Re: Second Comment by Kurt A. Fisher on 4th Avenue Well Chemical Treatment Plant
Securing the sodium hypochlorite tank against seismic risk; Option 2c location
alternative design

This letter is a comment with respect to the conceptual design phase of the Fourth Avenue Well Chemical Treatment Plant (the “Well”).¹ As noted in my first comment dated May 23, 2019, all of the proposed locations for the chemical treatment facility are located in seismic zones that will be subjected to high levels of ground shaking in the event of a greater than magnitude 6.75 earthquake. This comments recommends incorporating special engineering features to secure the Well’s proposed sodium hypochlorite tank against that seismic risk. Only complying with existing magnitude 5.0 earthquake standards would be insufficient in these premises. In Point II, I propose a concept design for the Hansen, Allen and Luce Report Option 2c alternative site (Figure 3) at the north end of City Creek Canyon Park..The concept design is of my own making and was done without consultation with or approval by residents in the immediate neighborhood. This siting proposal supplements and does not replace my May 23rd suggestion o

Figure 4- Concept schematic of the proposed facility from above and side.

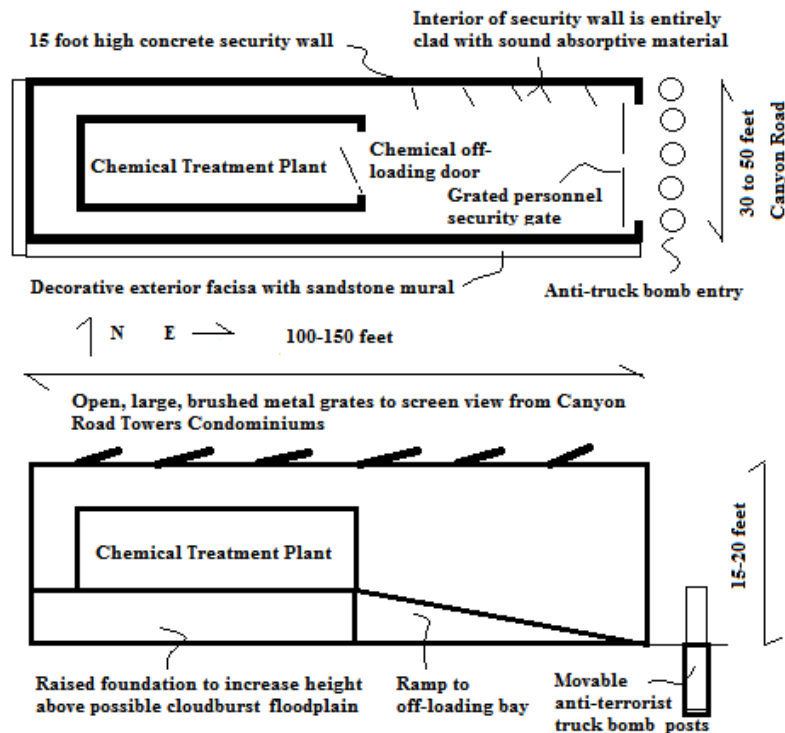
Figure 3 illustrates an anti-terrorist facility that is more resilient than the DPU's current concept design. Aesthetic features to make the facility better blend in with City Creek Park and the surrounding neighborhood include:

- An exterior decorative fascia on the exterior south and west walls with a sandstone mural depicting animals still commonly seen in City Creek Canyon, *e.g.* – Rocky Mountain elk, moose, eagles, falcons, mountain lions and coyotes.
- The interior would be clad with sound absorptive tiling.
- The top of the security enclosure would consist of wide open grates of brushed metal with the bottoms also clad in a sound absorbing material (not shown in figure). This open roof would screen the interior of the facility from the Canyon Tower Condominiums and summer tourists walking up State Street.
- Not shown in the schematic are removable stone ports around the exterior perimeter to allow firefighters to put water on the facility without having to enter the enclosure.
